SERVICE BULLETIN

NUMBER: 09-010-04 REV. A

4.0L Engine - Dirt And Debris Accumulation At Rear Main Seal

REPAIR PROCEDURE:**Fig. 1 LOCATION OF ADAPTER OPENING**

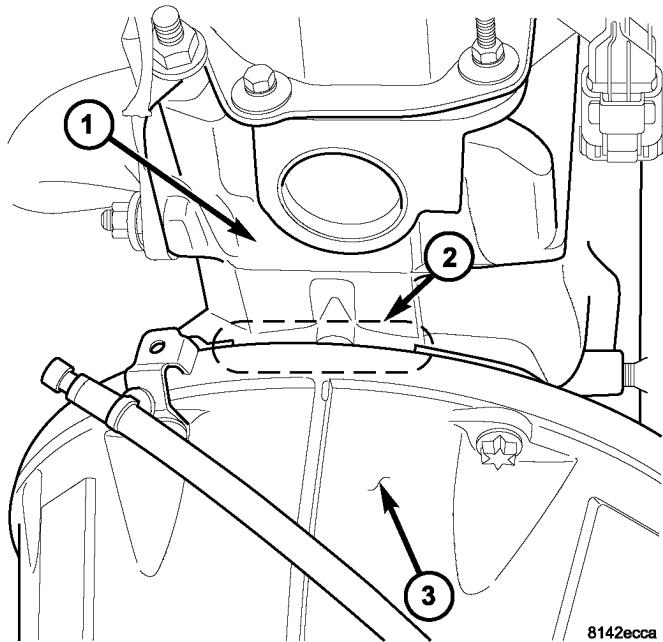
A spacer plate is used to mate the transmission bellhousing to the back of the engine. The spacer plate has a slot machined into it at the 12 o'clock position. A small opening may occur as a result of the spacer slot when the spacer is mated between the engine and transmission bellhousing. The narrow spacer opening at the top of the transmission bellhousing may allow small size debris to enter the bellhousing and accumulate around the outside of the rear main engine seal. If debris accumulation becomes significant, damage to the rear main seal may occur.

1. With the ignition switch in the off position, raise the vehicle hood and make sure the engine and exhaust manifold are not hot to the touch (Fig. 1).
2. Locate the narrow opening created by the spacer plate. The spacer opening can be viewed when looking towards the rear of the engine and top of the transmission bellhousing from the drivers side of the engine (Fig. 2).
3. Thoroughly clean the immediate area around the spacer opening with throttle body cleaner, p/n 04897156AA. Allow cleaner to dry.
4. Apply a sufficient amount of RTV over the spacer opening. Verify that the spacer opening is completely sealed off by the RTV.
5. Lower and secure vehicle hood.

Fig. 2 ADAPTER OPENING DETAIL

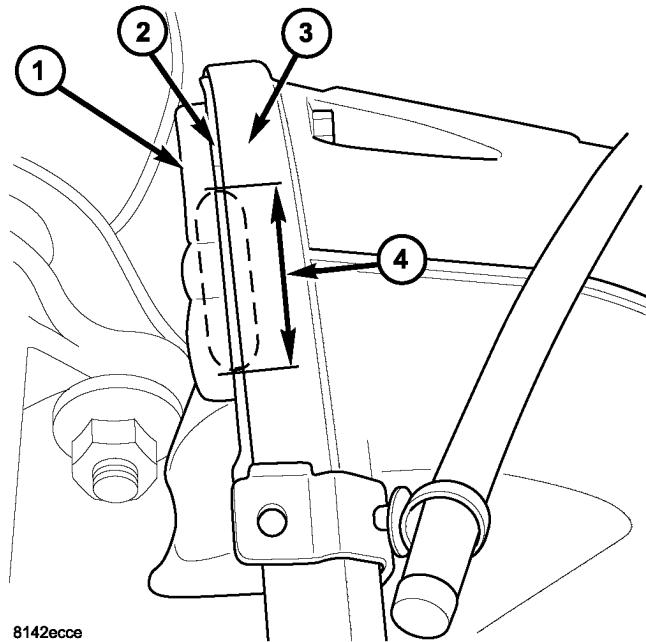
- 1 - BACK OF ENGINE
 - 2 - ADAPTER PLATE
 - 3 - BELLHOUSING - MANUAL TRANSMISSION
 - 4 - ADAPTER PLATE OPENING - APPLY SEALER HERE
-
